## ADDENDUM NO. 3

PROJECT: Saline Area Schools – 2022 Bond Program – MS Rec Complex  
DESCRIPTION: Addendum No.3  
BID PACKAGE RELEASE NUMBER: BP #3

1. ADDENDUM No. 3, December 3<sup>rd</sup>, 2024 as issued by Kingscott (Attached)

ELECTRICAL SITE DEMOLITION PLAN - WEST

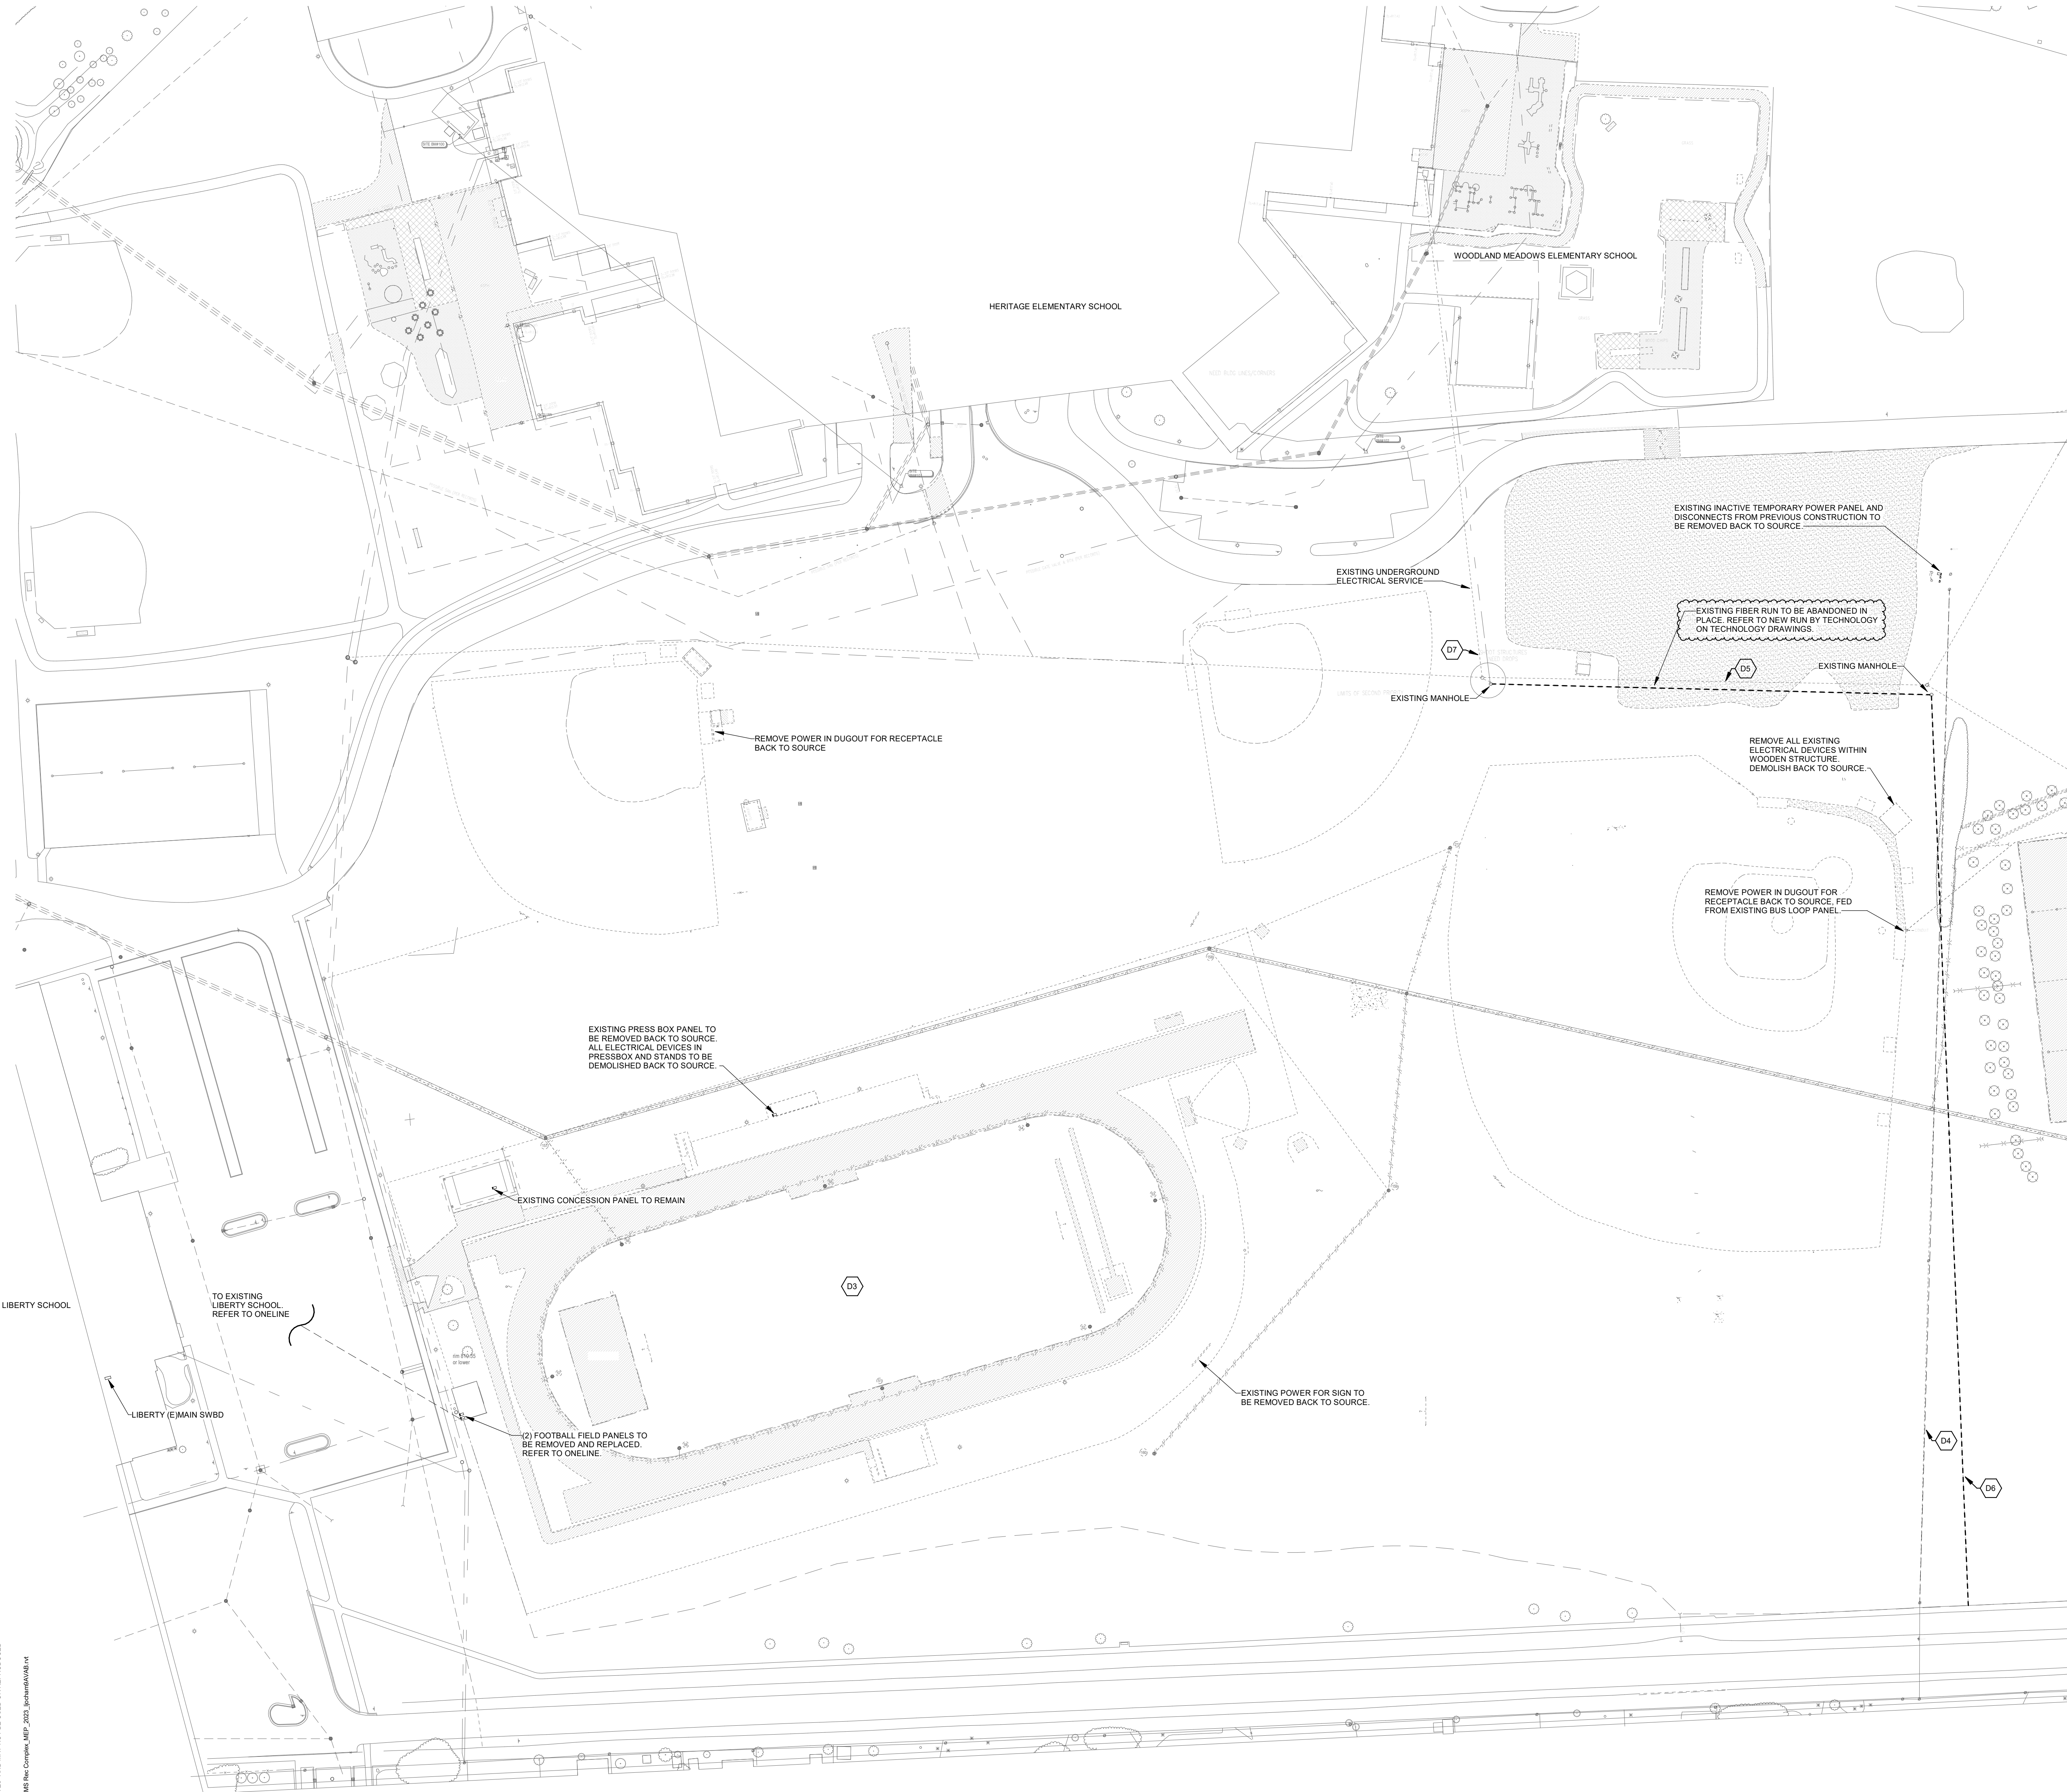
- Item No. 1. Refer to sheet ESD1.1W (re-issued):  
A. Added note for demolition of fiber conduit.
- Item No. 2. Refer to sheet ES1.1E (re-issued):  
A. Added construction keynote.  
B. Added conduit for fiber for technology coordination.
- Item No. 3. Refer to sheet ES1.1W (re-issued):  
A. Added construction keynote.  
C. Added conduit for fiber for technology coordination.

SHEET NO.  
**ES1.1W**

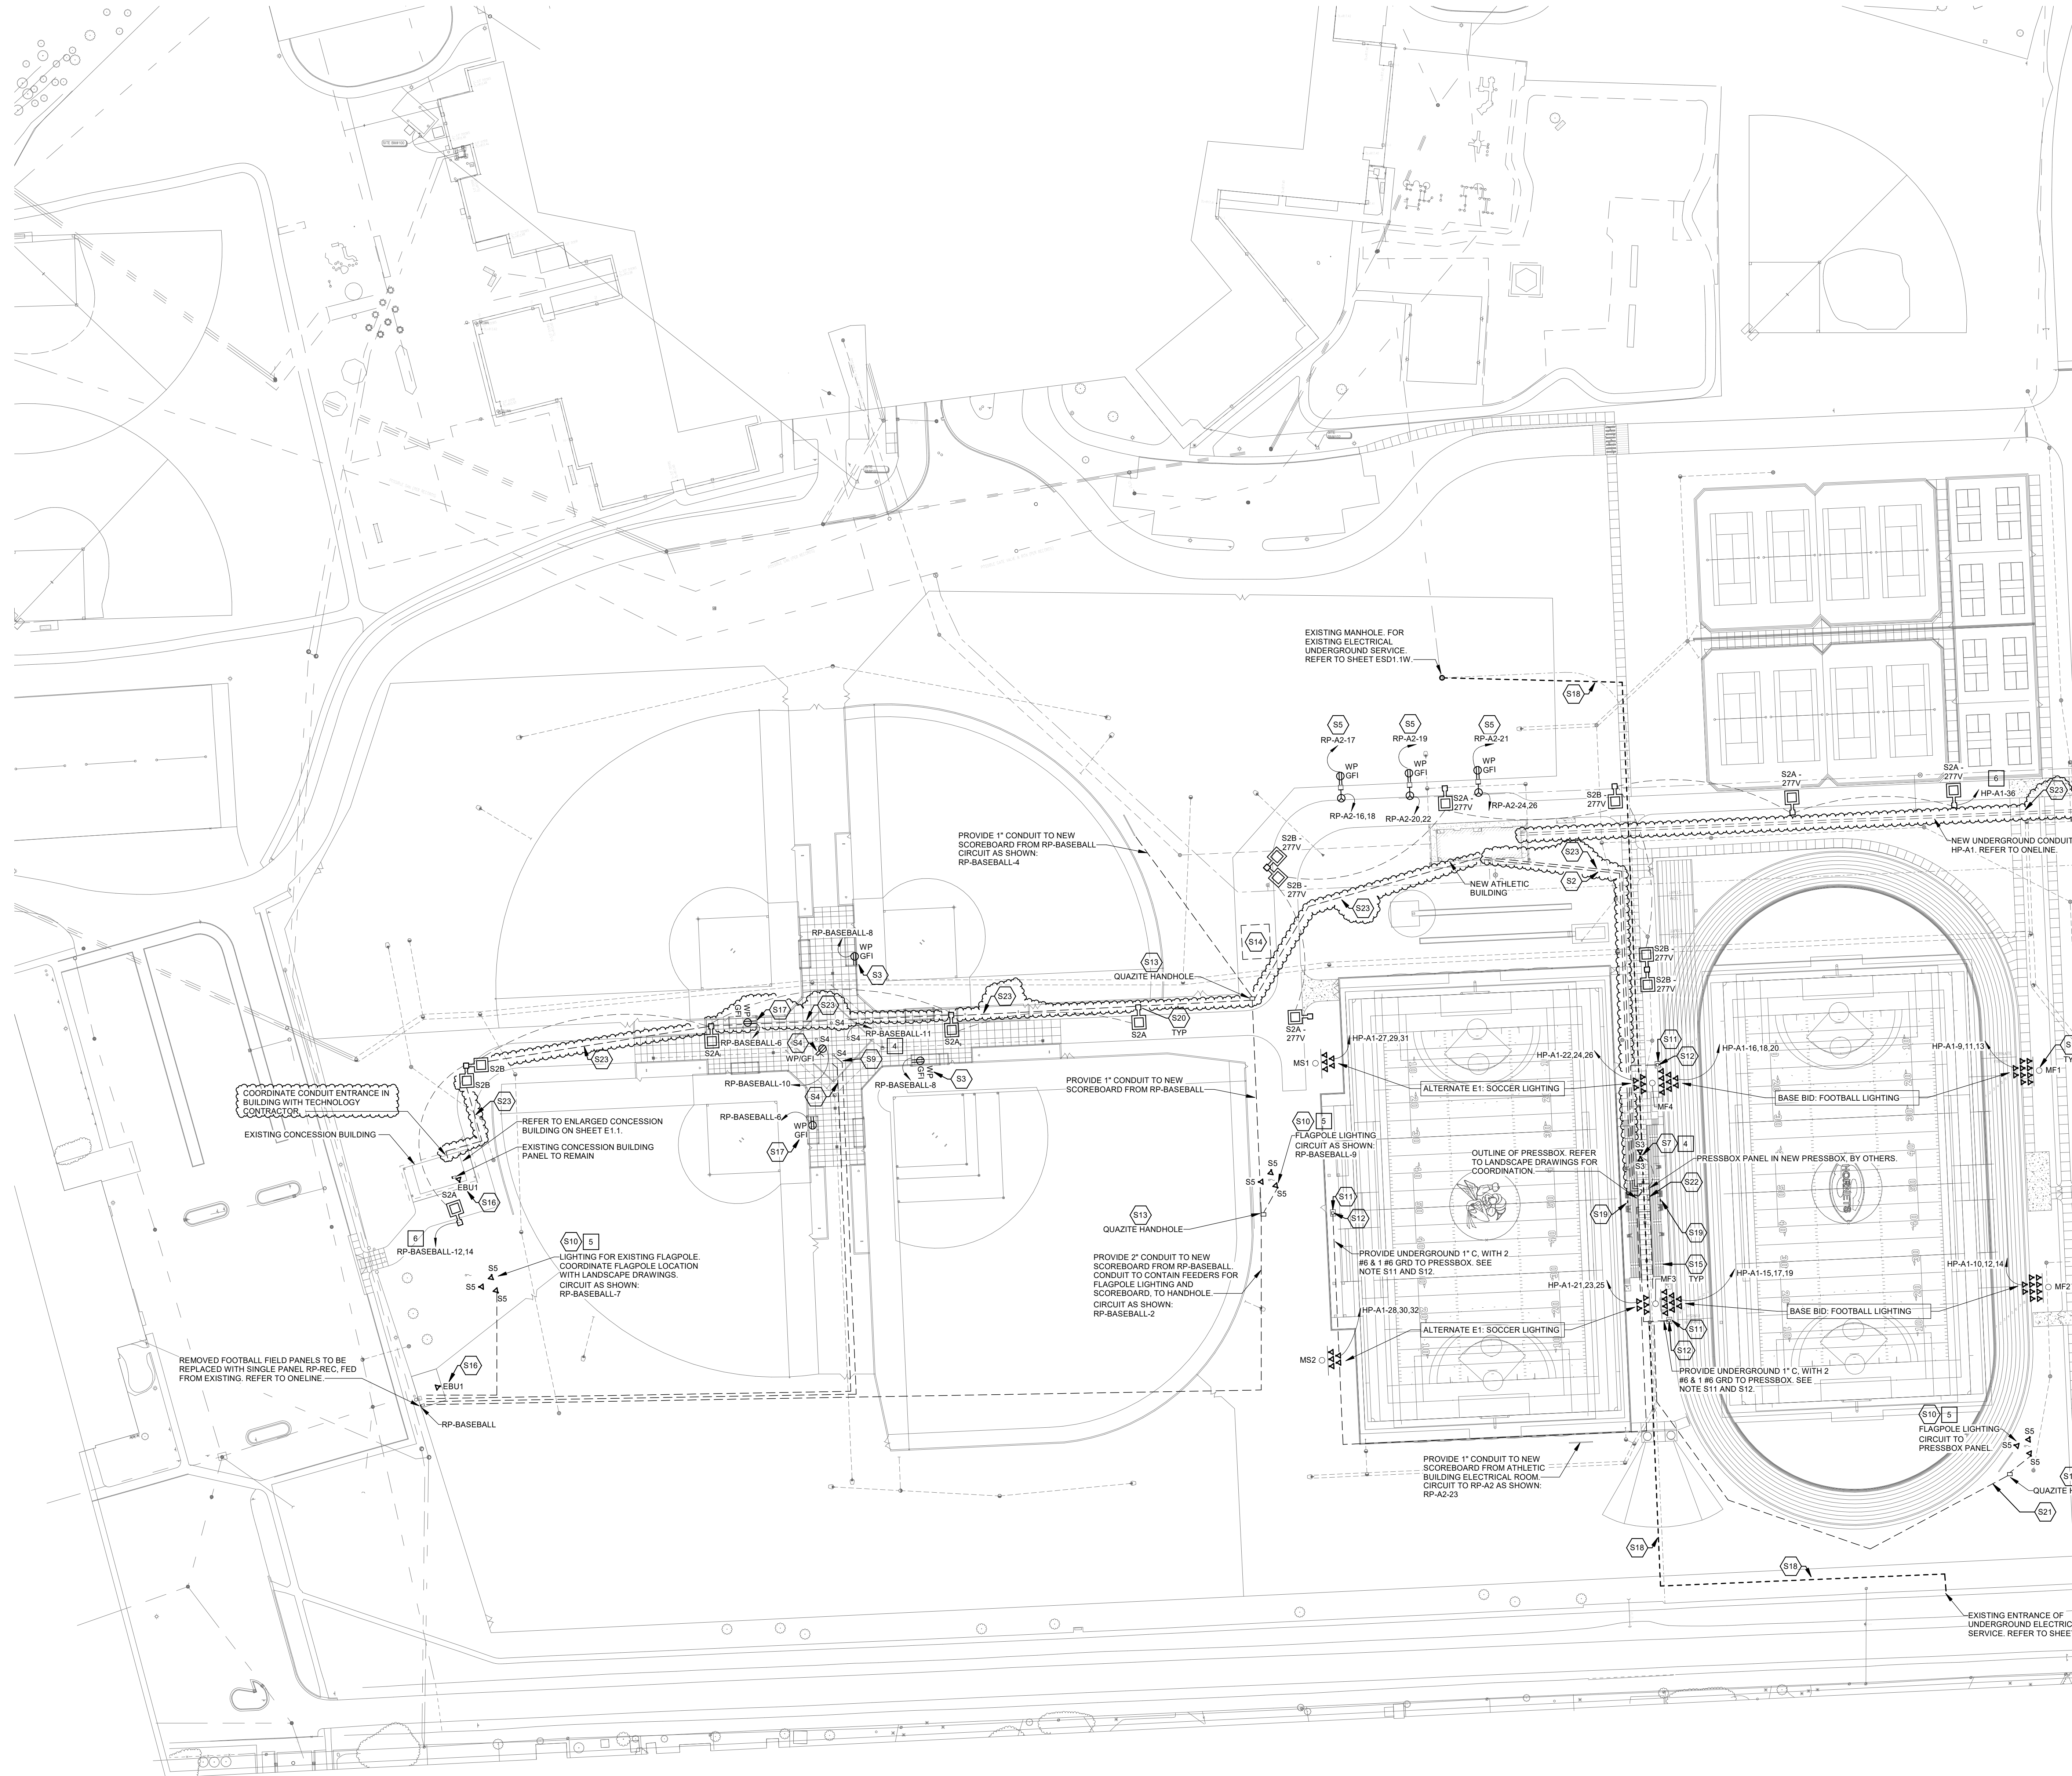
2. On the new work site plan, ES1.1W, note S18 states, "Suggested new underground electrical service route to existing manhole". There are no size or quantity of conduits / conductors listed. Also, there are no size or amounts of conduits / conductors shown on Print E7.0 or E7.1 for the Middle School and Elementary School. Please advise.

Assume the new conduit to replace the existing shall be (2) 5" conduits for the bidding estimate.

**12 FLAG POLE FOUNDATION**  
SCALE 1/2\"/>

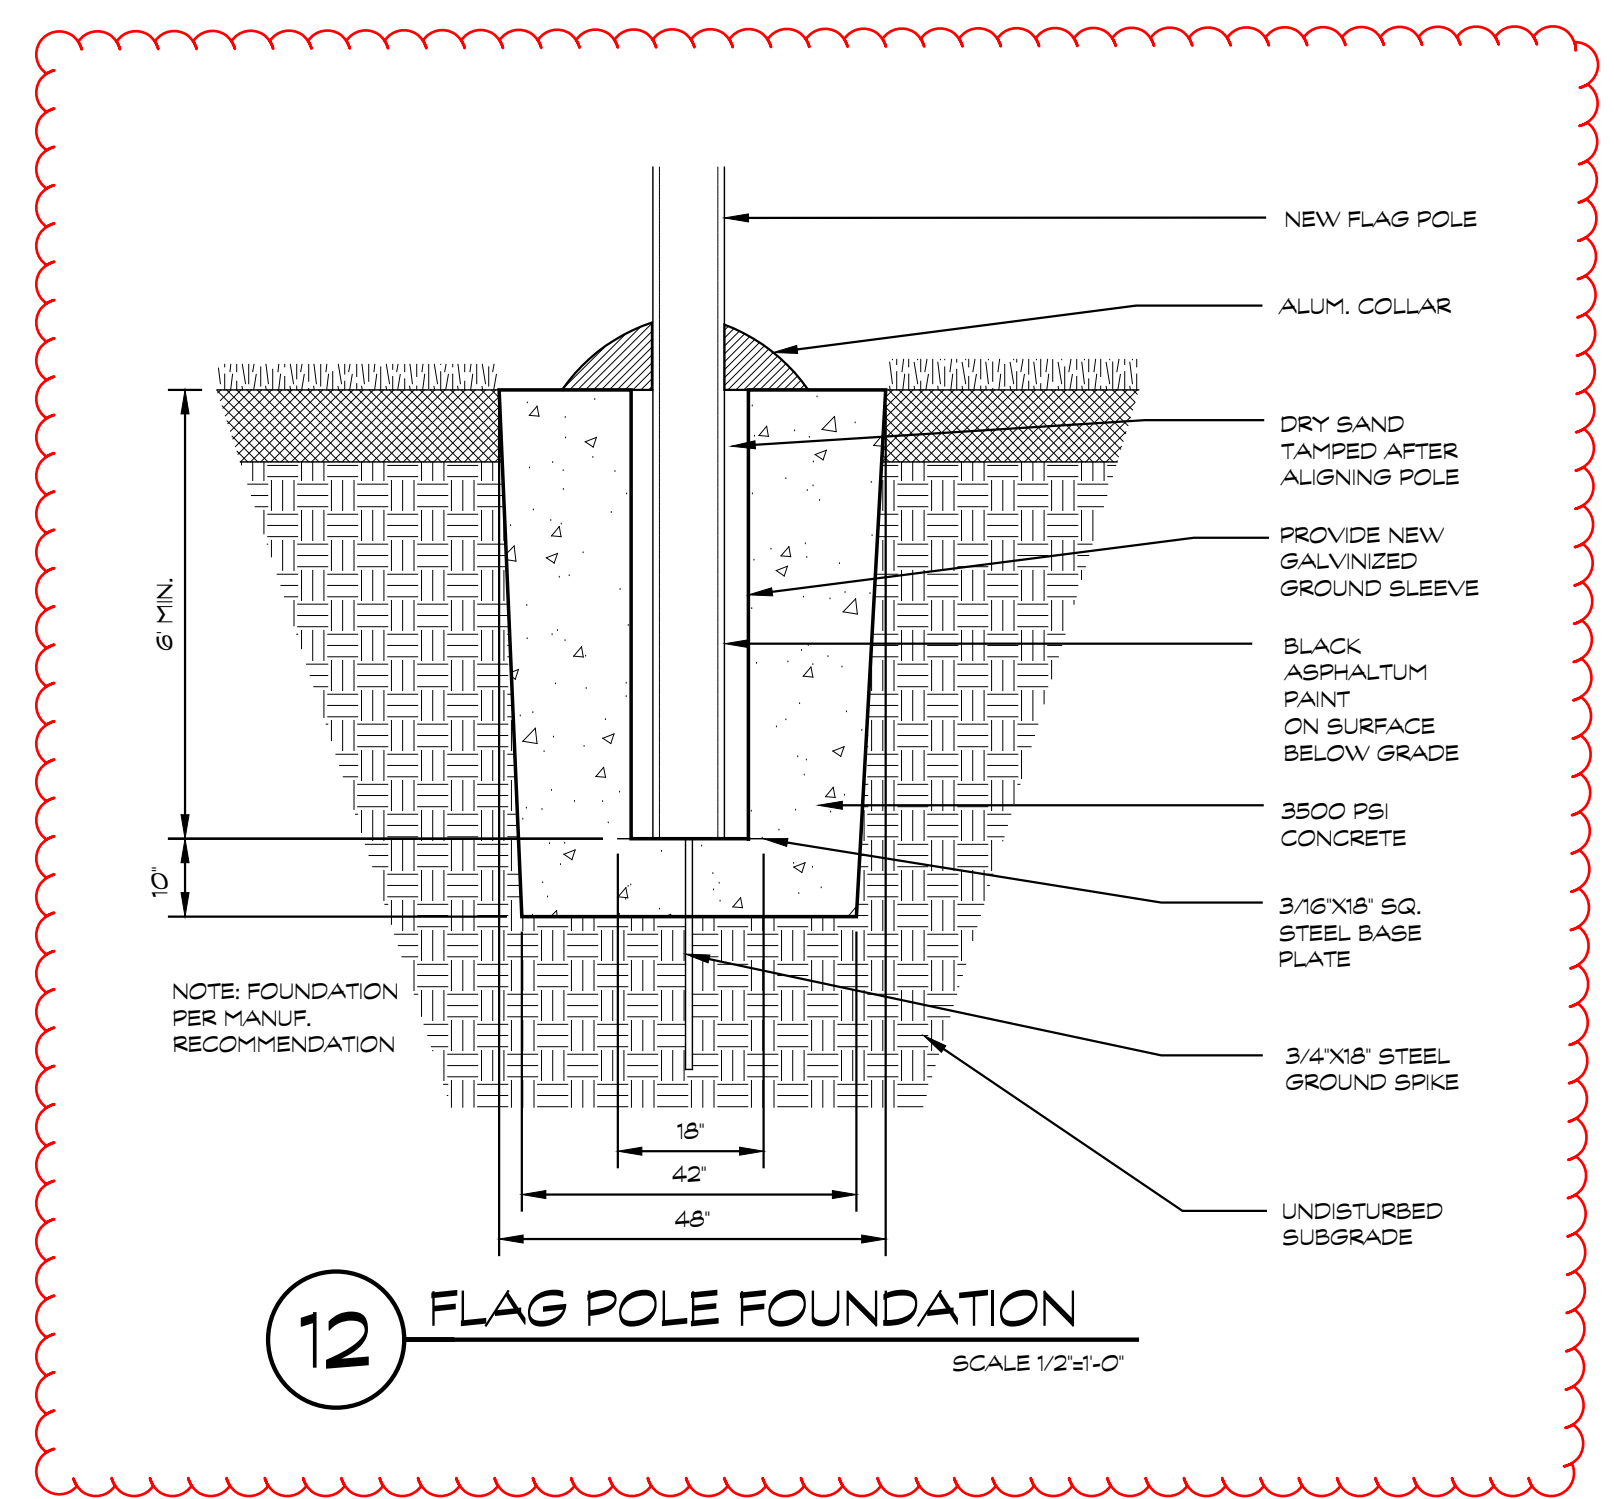
I did not see the flag pole detail on 12/LD4.01 it seems to be missing, or is it on another page?

See Addendum 003 for flagpole detail located on LD4.01 detail 12.  
.....

# Asphalt Delineation Example

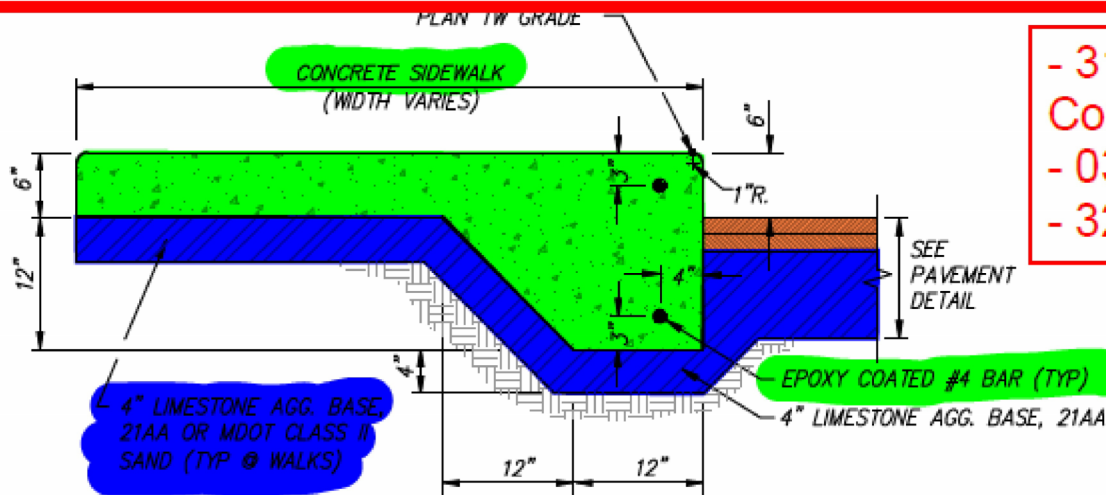
- 31A - Furnish, Grade and Compact 6" Class II Sand Base
- 32A - Fine Grade

- 31A - Furnish, Grade and Compact 6" Class II Sand Base
- 03 - Fine Grade
- 32A - Fine Grade

- Install base per design details. Notes in red are meant for delineation of scope only. Contractors to include cost of base required per the engineering details (i.e. 10" stone under asphalt, 4" stone under concrete sidewalk, etc).
- 31A is required to furnish stone under asphalt, with the exception of the Athletics' Track. 32A is required to furnish, grad and place stone for the track per the delineation in Attachment A.
